WESTINGHOUSE NUCLEAR SAFETY
SAFETY EVALUATION CHECK LIST

- 1) NUCLEAR PLANT(S) : BYRON/BRAIDWOOD UNITS 1 & 2
- 2) SUBJECT (TITLE): RELAXATION OF MSSV SETPOINT TOLERANCE TO +/-3%

BYRON/BRAIDWOOD UNITS 1 AND 2
INCREASED MAIN STEAM SAFETY VALVE SETPOINT TOLERANCE
SAFETY EVALUATION

FIGURE 15.2-1

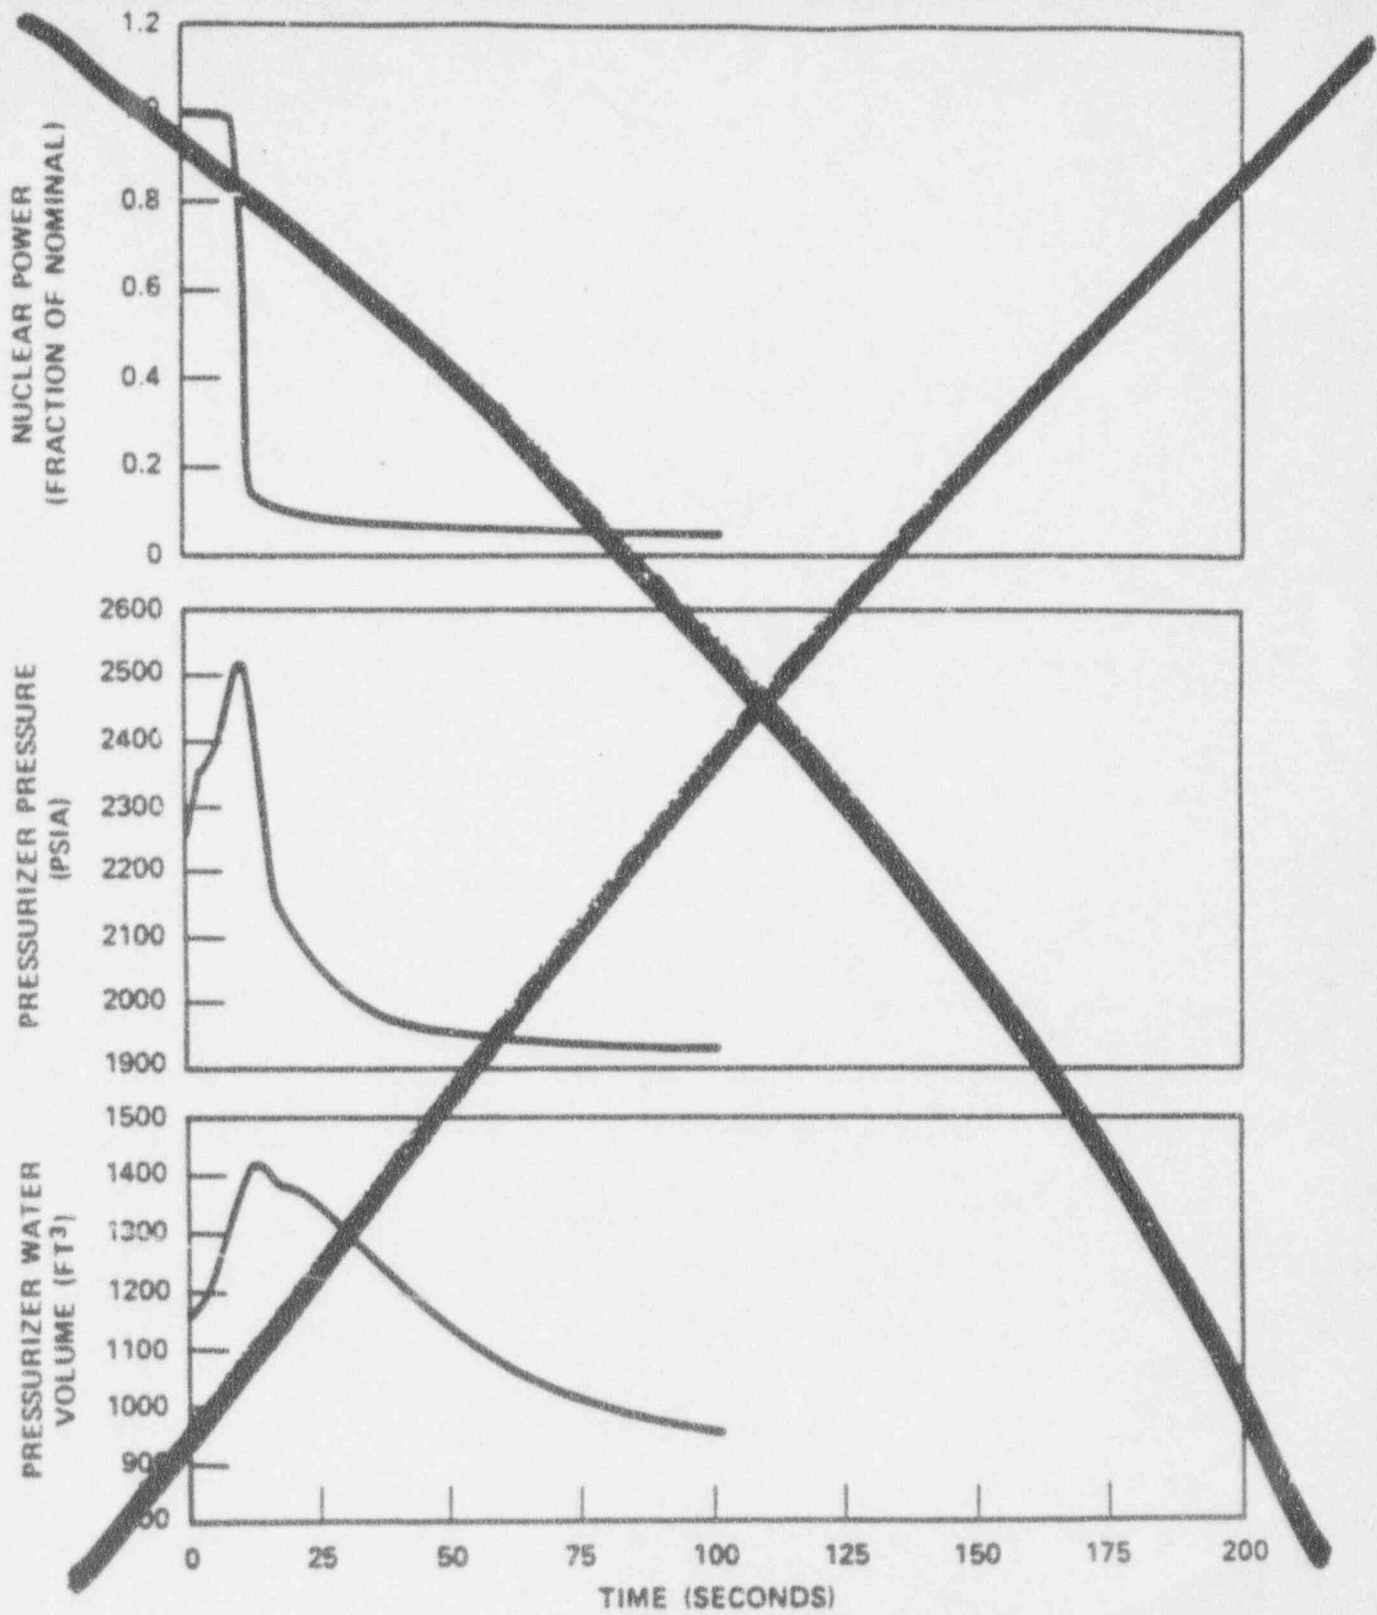
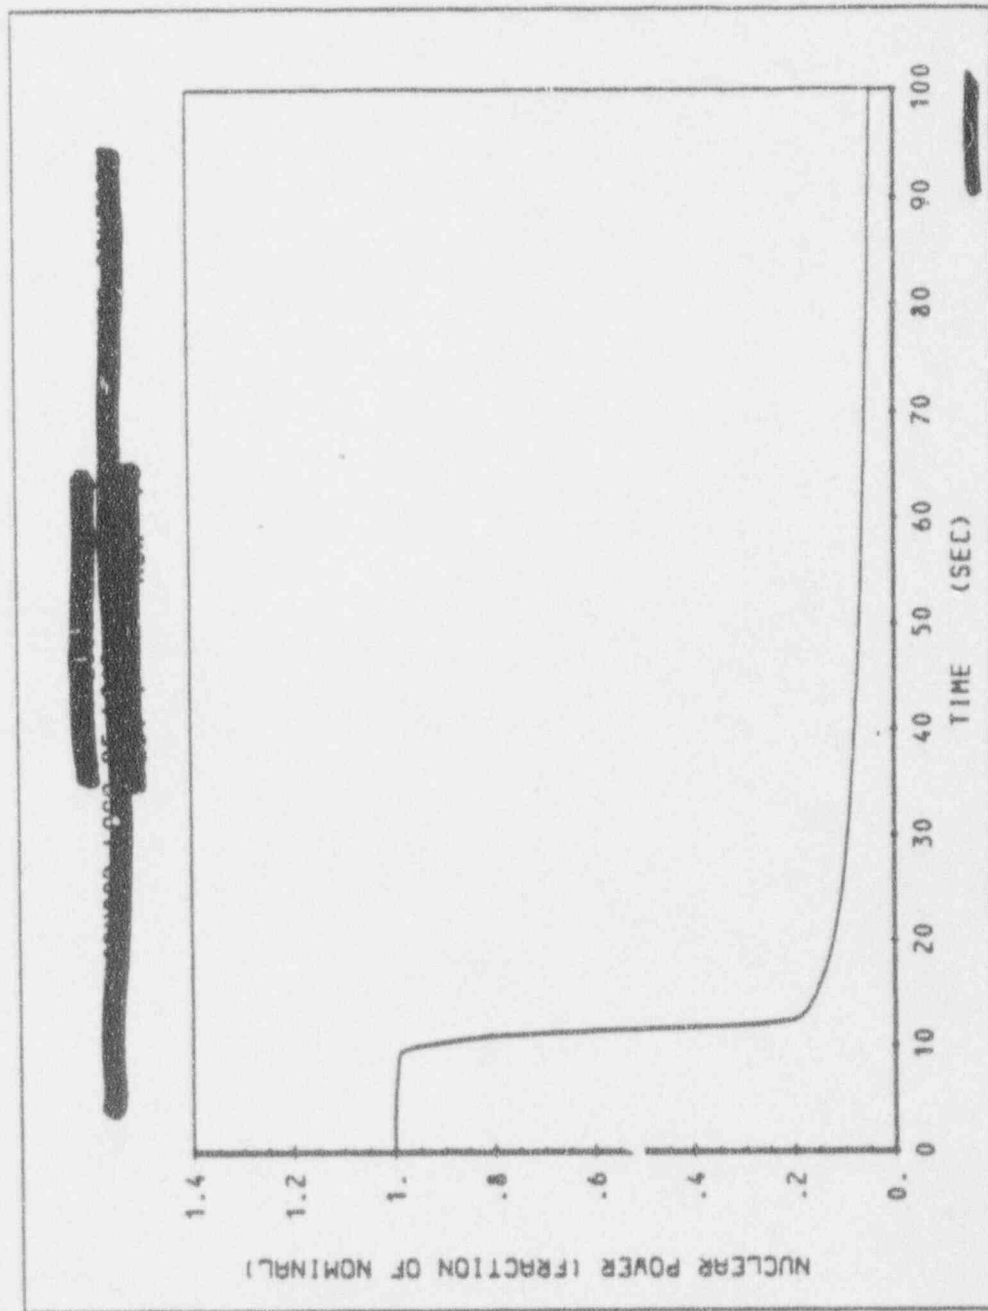
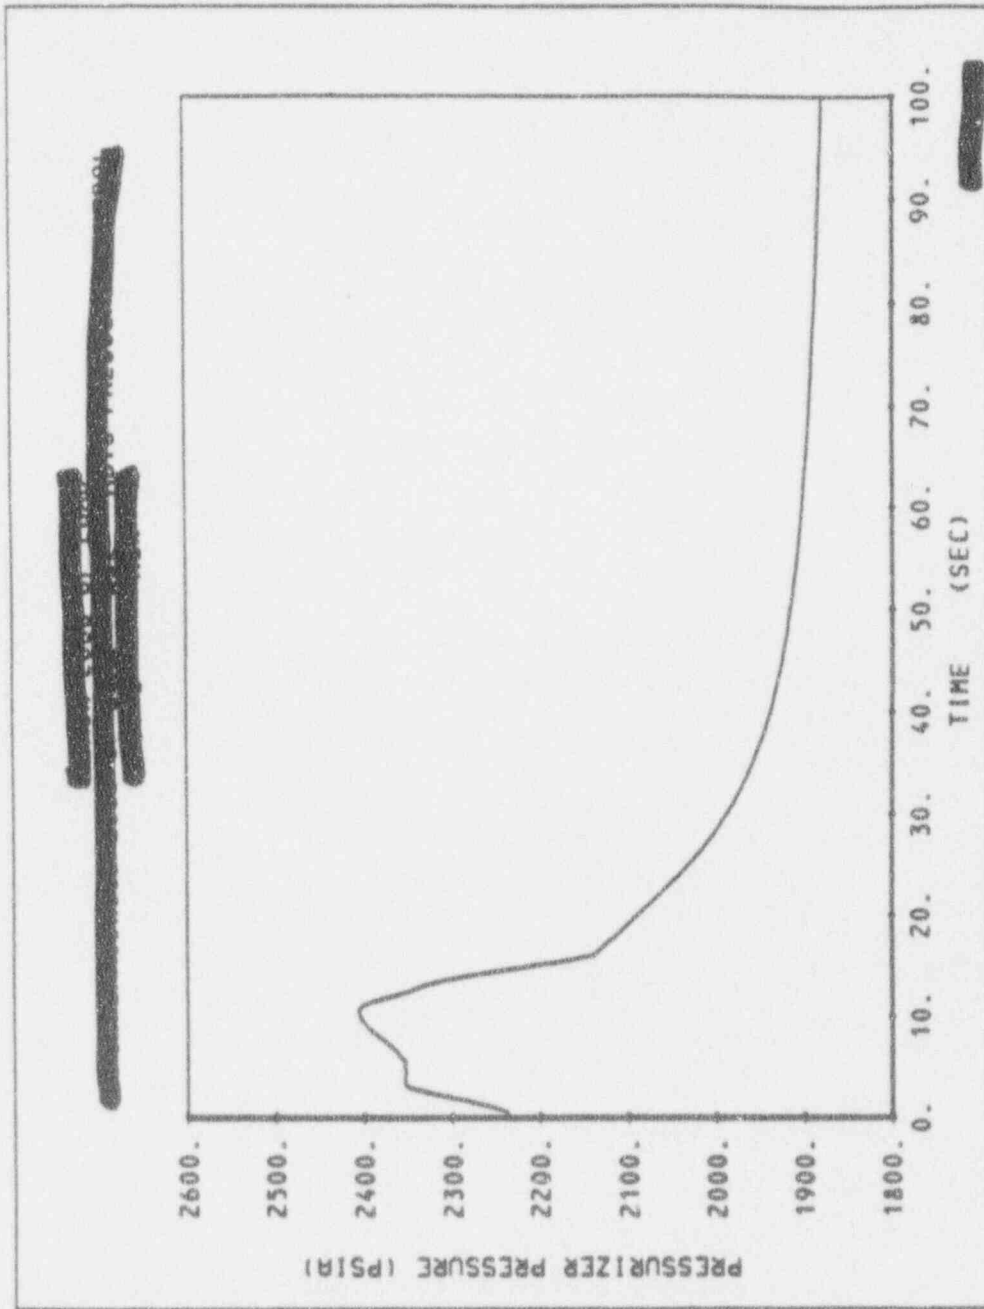
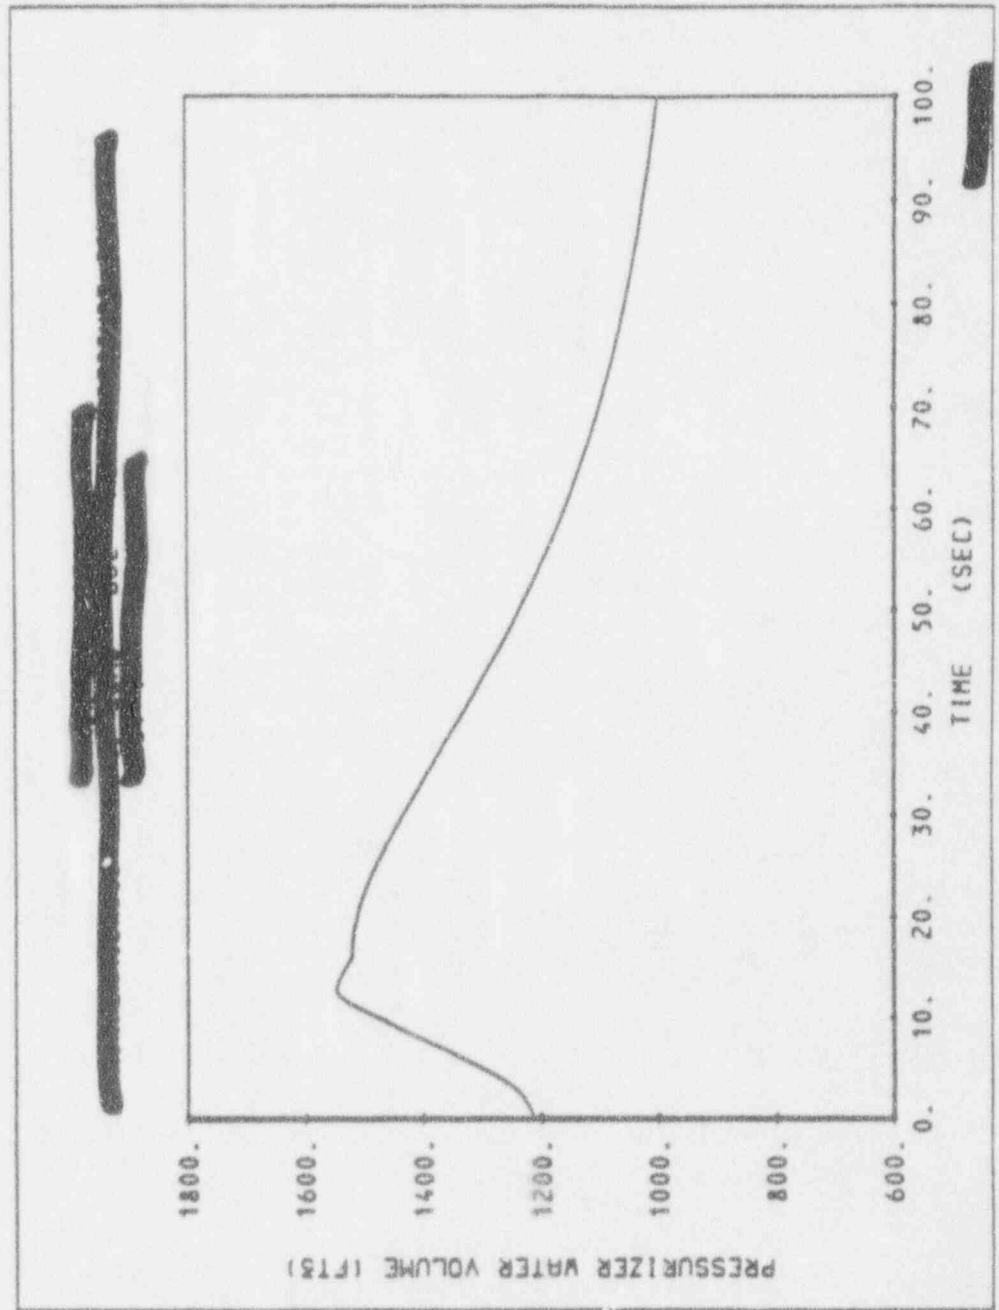
Figures 15.2-1 and 15.2-2 show the transient responses for the total loss of steam load with a least negative moderator temperature coefficient assuming full credit for the pressurizer spray and pressurizer power-operated relief valves. No credit is taken for the steam dump. The reactor is tripped by the ~~high-pressurizer pressure~~ trip channel. The minimum DNBR remains well above the limit value. The ~~pressurizer safety valves~~ are actuated and the primary system pressure remains below the 110% design value. The steam generator safety valves limit the secondary steam ~~conditions to saturation at the safety valve setpoints.~~ pressure to less than 110% of the design value.

REPLACE WITH
The following
Figures
